Results of Detailed Check of Bumper Test Area Definitions Proposed by EC (Gage Method)

8th TF-BTA Meeting
21/November/2014

Japan Automobile Standards Internationalization Center (JASIC)

TF-BTA-8-03r1

Tires and Door Mirrors

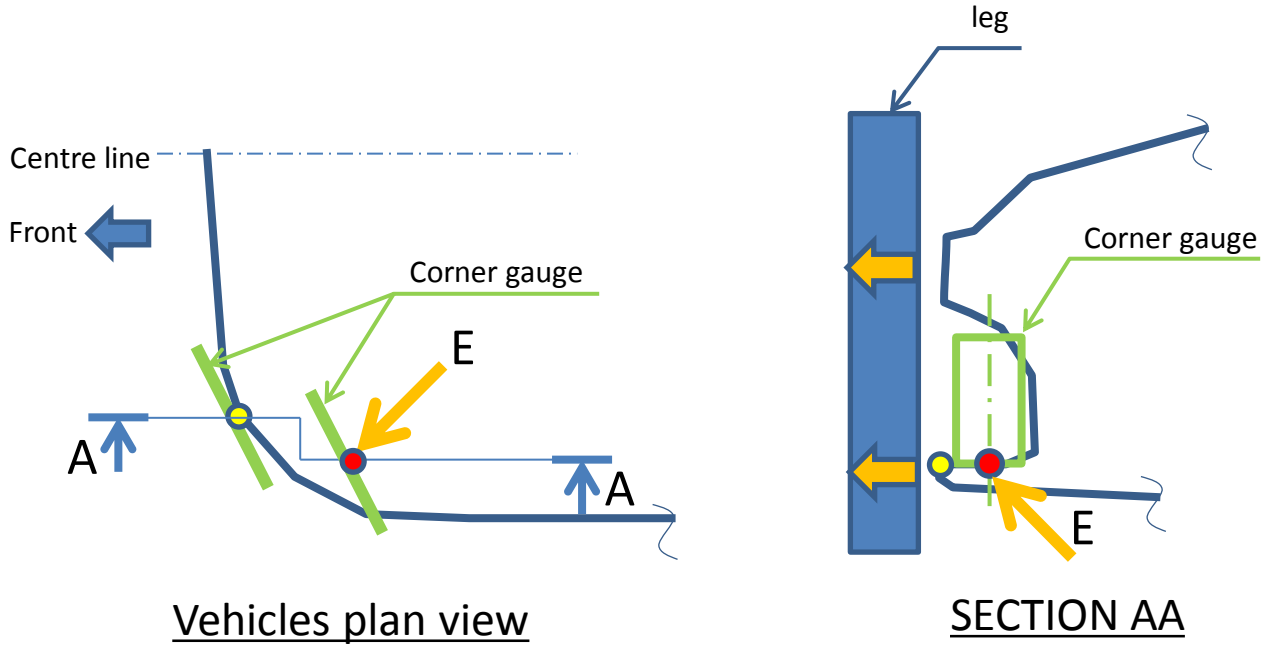
The bumper test area may be determined by a tire or a door mirror, which are both irrelevant to leg impact.

We propose to eliminate tires and door mirrors from a search for the contact points with the gage.

Concave Shapes of Bumper Face

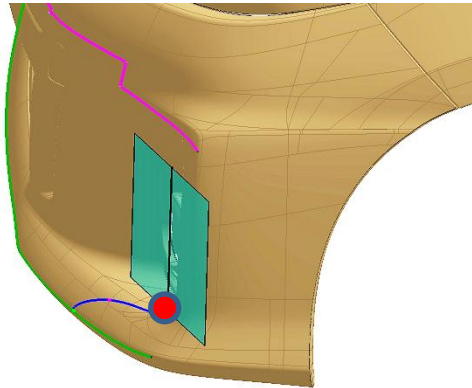
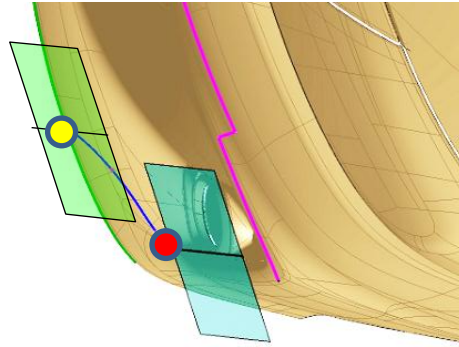
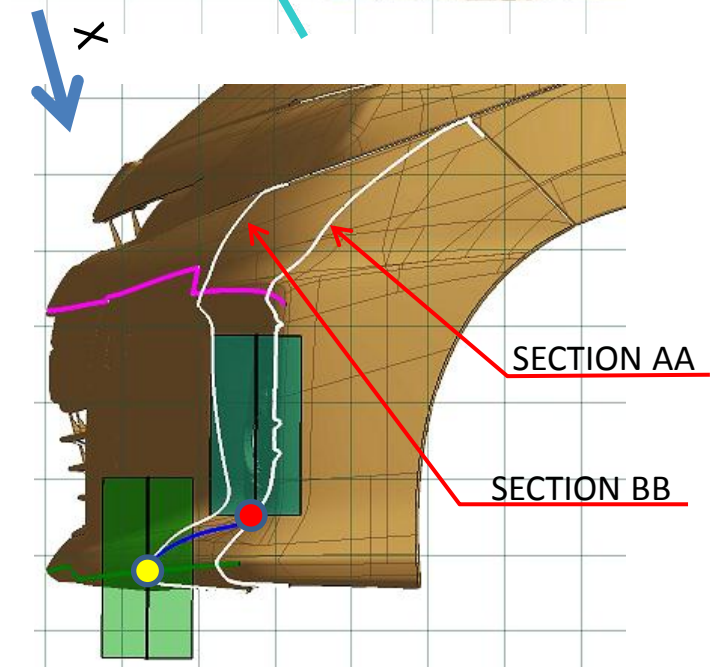
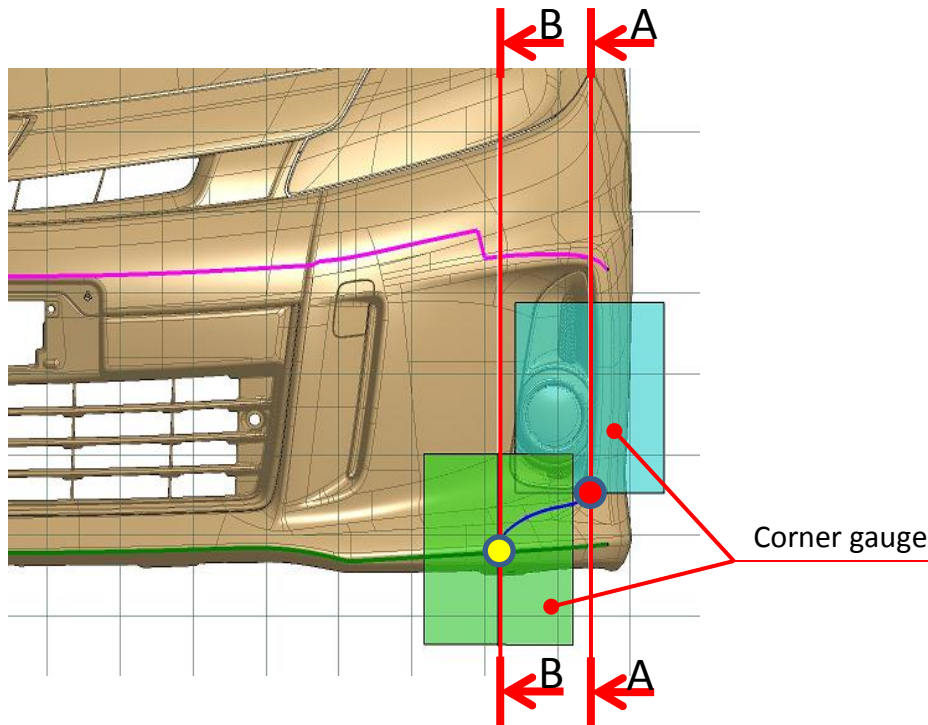
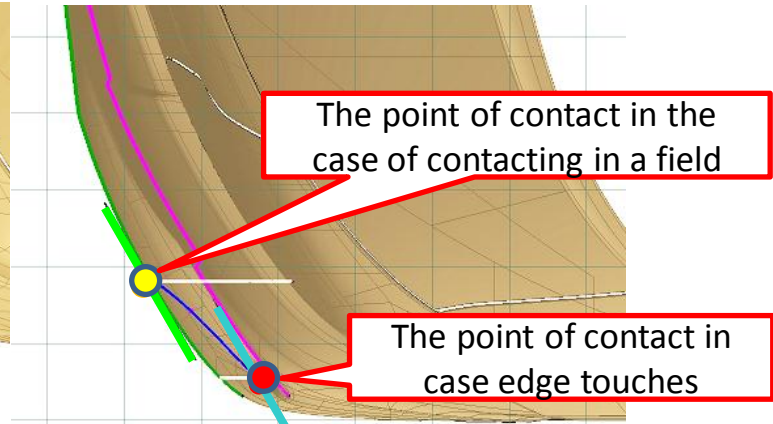
The bumper test area may be determined by the contact points with the gage that cannot make contact with the leg. (Following figure E part)

- The edge of a gage contacts the concave portion, which cannot contact the leg.
- It is not appropriate to define the bumper test area using the contact points irrelevant to the leg impact.

We propose to eliminate the upper and lower edges of the gage to determine the contact points.

Consistency of Wording

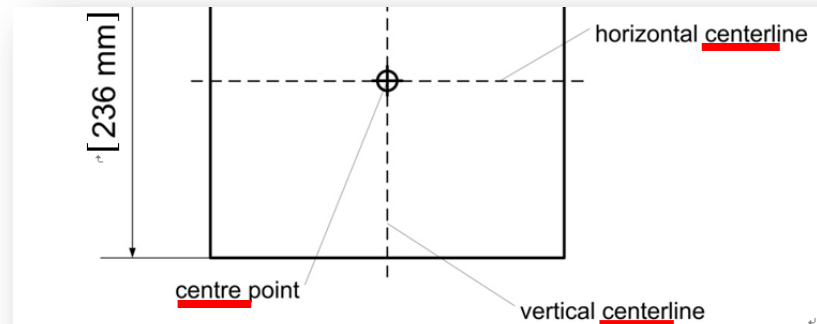
Some inconsistencies in wording were found.

“bumper corner” and “corner of bumper”

“center” and “centre”

We propose to modify some words for consistency.
